# Access Compliance Report

## Public Rights-of-Way

### (Curb Ramps)

Intersection ID: 3031	Main Street: AMBER_GLEN_DR	Cross Street: AZURE_VALLEY_PL	Location: E
ADA ID: 07C72CE7A569	Ramp Type: Perp	Initial Pass/Fail: Fail	Overall Compliance: No
Codes/Mitigation Info/Possible Solution		Field Measurements/Component Compliance	
		Severity Score: 10

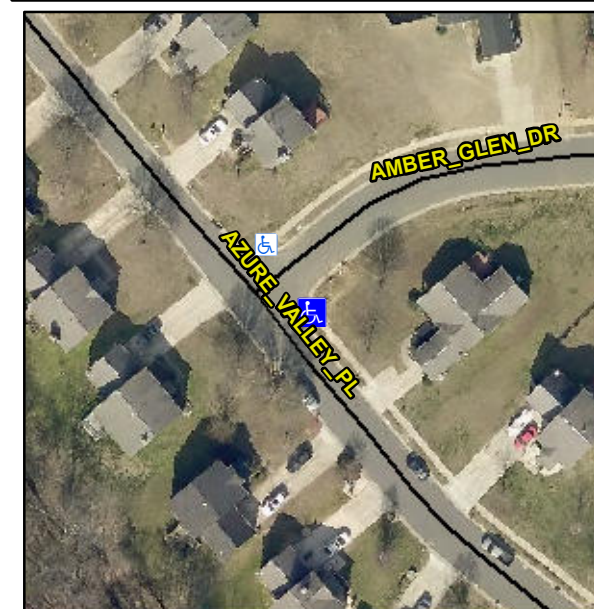
**Not Found, R304.5.1, R304.5.3**

Compliance	Description	Data	Compliance	Description	Data
N/A	Ramp Length (in)	47.0	Yes	Ramp Slope (%)	5.0
No	Ramp Width (in)	47.0	No	Ramp XSlope (%)	2.9
N/A	Flare Type LT	N/A	N/A	Flare Type RT	N/A
N/A	Flare Slope LT (%)	N/A	N/A	Flare Slope RT (%)	N/A
N/A	Flare Traversable LT?	N/A	N/A	Flare Traversable RT?	N/A
N/A	Landing Length (in)	N/A	N/A	DWS Provided?	N/A
N/A	Landing Width (in)	N/A	N/A	DWS Contrast?	N/A
N/A	Landing Slope (%)	N/A	N/A	DWS Length (in)	N/A
N/A	Landing X Slope (%)	N/A	N/A	DWS Full Width?	N/A
N/A	Landing Curb? (Y/N)	N/A	N/A	DWS Offset (in)	N/A
N/A	Shared Landing?	N/A			
N/A	Gutter Ponding?	N/A	N/A	Gutter Slope (%)	N/A
N/A	Gutter Lip Ht (in)	N/A	N/A	Gutter X Slope (%)	N/A
N/A	Painted X Walk1?	No	N/A	Painted X Walk2?	N/A
	X Walk 1 Direction	To NW		X Walk 2 Direction	N/A
N/A	X Walk 1 Width (in)	N/A	N/A	X Walk 2 Width (in)	N/A
	X Walk 1 Slope (%)	4.9		X Walk 2 Slope (%)	N/A
	X Walk 1 X Slope (%)	1.2		X Walk 2 X Slope (%)	N/A

**Remove & Replace Entire Ramp.**
